UNITED STATES PATENT AND TRADEMARK OFFICE

APPLICATION NO.	FILING DATE	FIRST NAMED INVENTOR	ATTORNEY DOCKET NO.	CONFIRMATION NO.
10/080,849	02/22/2002	Aaron J. Hanna	K35A1056	9641

Office Action Summary	Application No. 10/080,849	Applicant(s) HANNA ET AL.	
	Examiner Christopher R. Magee	Art Unit 2653

DETAILED ACTION

FIGURE 5

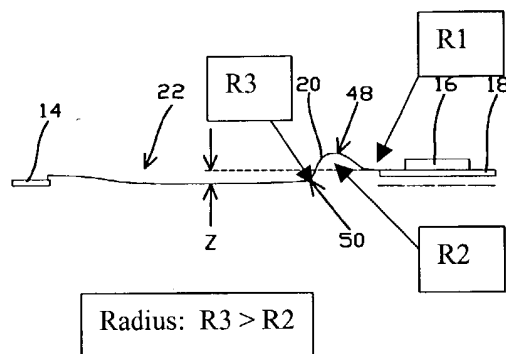
- Regarding claims 5, 10, 14, 18, 22, 26, 31, 36, 41, 46, 50 and 54, Jagt shows the radius geometry includes a first radius of curvature, a second radius of curvature and a third radius of curvature, the first radius being closer to the mount plate than the second radius, the second

radius being closer to the mount plate than the third radius, and wherein the third radius is greater than the second radius [see embedded Fig. 5].
